**Addendum No. 3**

**Invitation for Bids (“IFB”) No. DCAM-22-CS-IFB-0009**

**Construction Services for Youth Services Center  
Roof Replacement and Upgrades**

**Issued: January 13, 2023**

AHU Curb at Area L 6 SCALE : N.T.S.

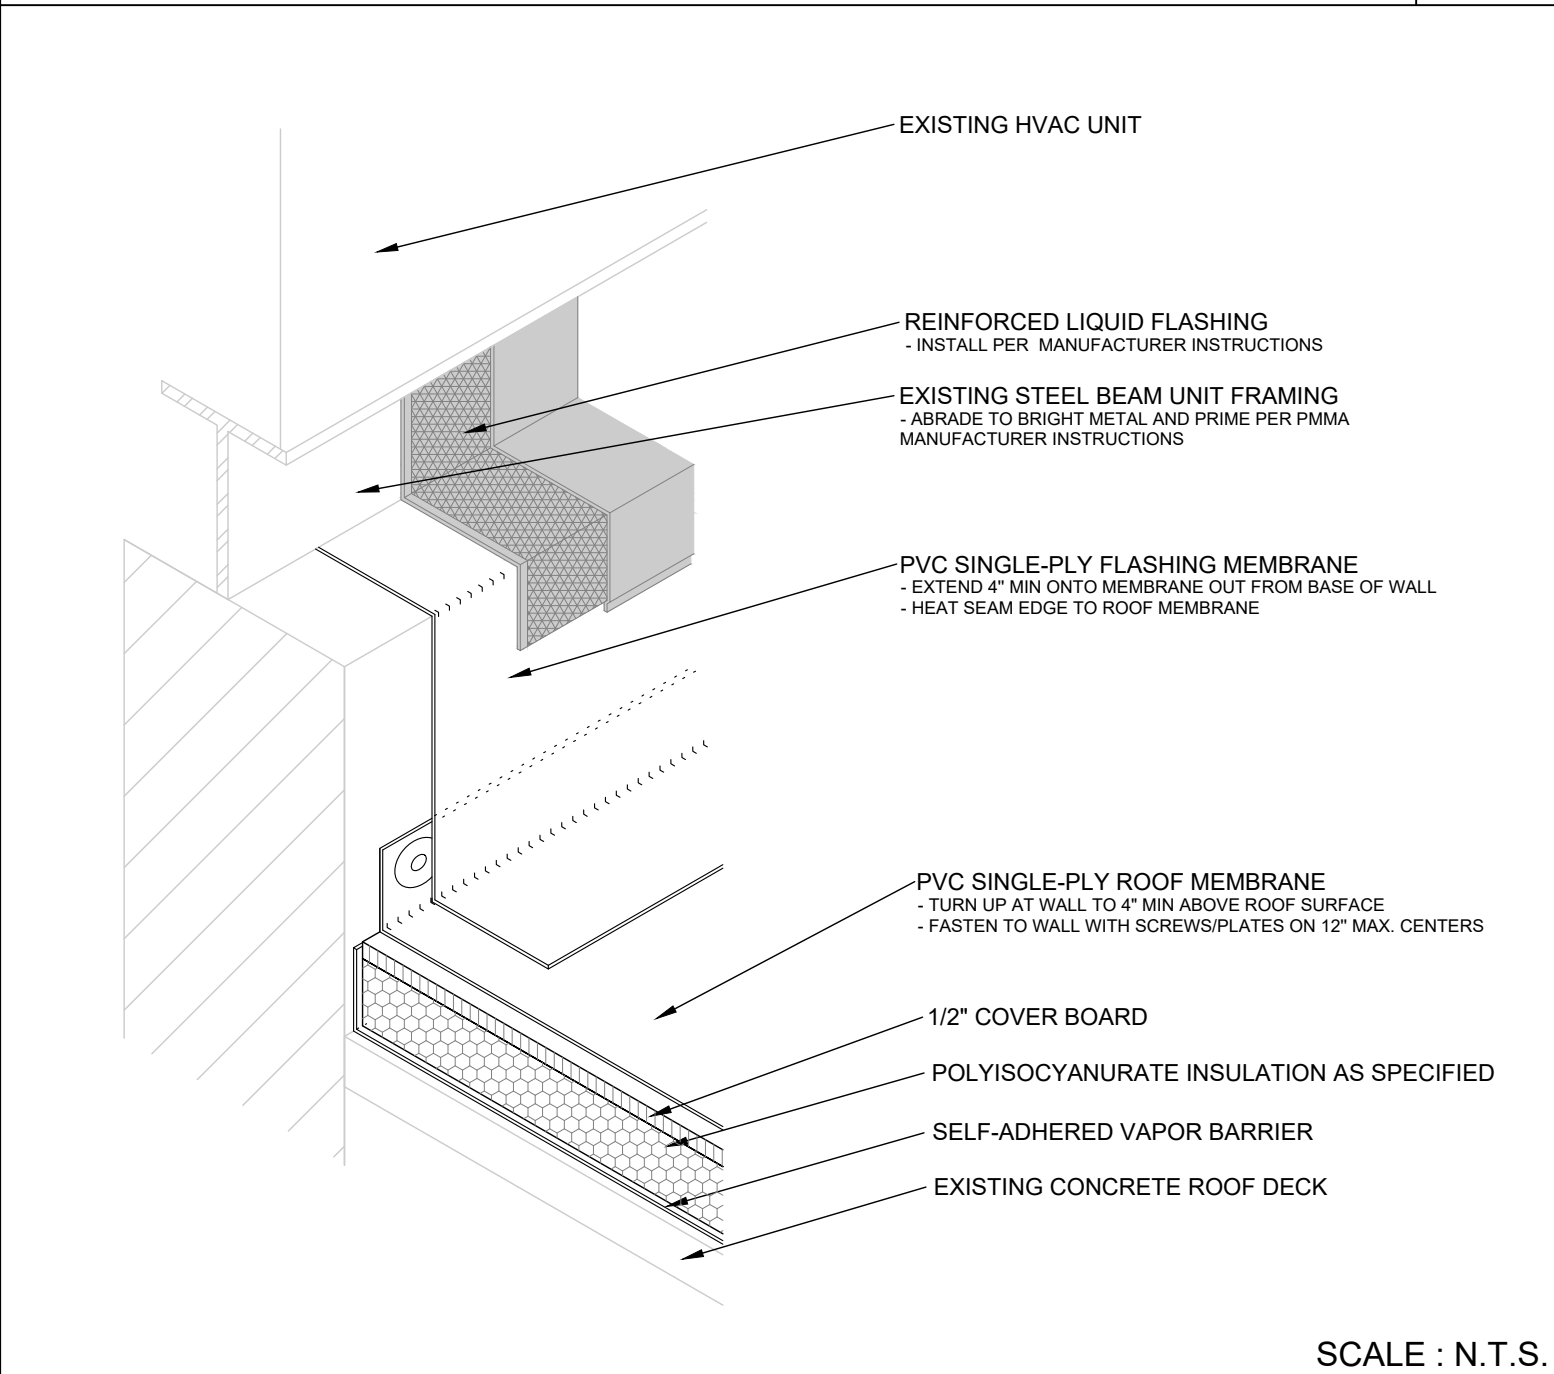
4	Please confirm no HVAC or electrical work in this scope of work and contract.	Pipe raising related to the HVAC on Roof Area L is required. Revised Drawings are provided through Addendum No. 3 in this regard.
5	Please confirm no building permit is required for this job, if yes, please provide an allowance to cover the building permit and expedite permit fee.	A building permit is required in DC on any reroof or upgrade project over 100 square feet. The revised form of offer and bid form provided through Addendum No.3 includes the allowance.
